Manitowoc **Parts & Service Communicator**

Subject: S Model Dispenser Agitator Pin Change

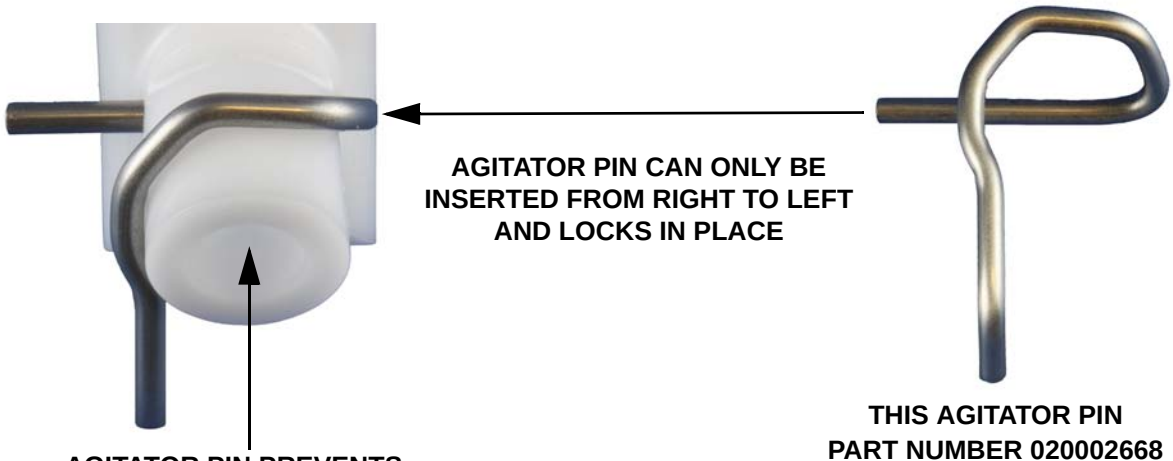
Agitator pins required insertion in the correct direction to prevent ice from dislodging the pin. The previous version of the agitator pin could be inserted in the wrong direction and the pin would fall out. The current version has been designed to prevent incorrect insertion and also has an improved locking feature. This pin is the replacement part for all dispensers with front serviceable motors (serial number 610050366 or larger).

AGITATOR PIN REQUIRES INSERTION FROM RIGHT TO LEFT TO PREVENT ICE PRESSURE FROM DISLODGING PIN - THIS PIN STYLE IS REPLACED BY THE VERSION ABOVE THAT CAN NOT BE INSERTED INCORRECTLY

AGITATOR PIN CAN ONLY BE INSERTED FROM RIGHT TO LEFT AND LOCKS IN PLACE

AGITATOR PIN PREVENTS AGITATOR SHAFT FROM SHIFTING BACKWARD AND DISCONNECTING FROM MOTOR

THIS AGITATOR PIN PART NUMBER 020002668 REPLACES THE PREVIOUS VERSION
